Remarks

Applicants have amended errors in the specification and the detailed drawings (Fig. 6). The amended sentences and drawing are consistent with the specification as originally filed and consistent with the amended claims. No new matter has been added.

FIG. 6

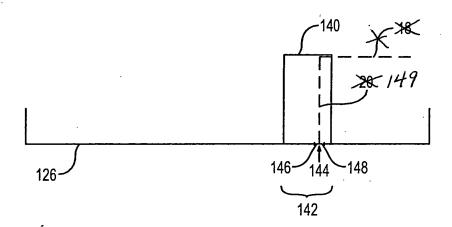
In Fig. 6, delete the reference numeral "18" and its associated tagline.

In Fig. 6, delete the reference numeral "20" and insert in place thereof the reference numeral - -149- -.
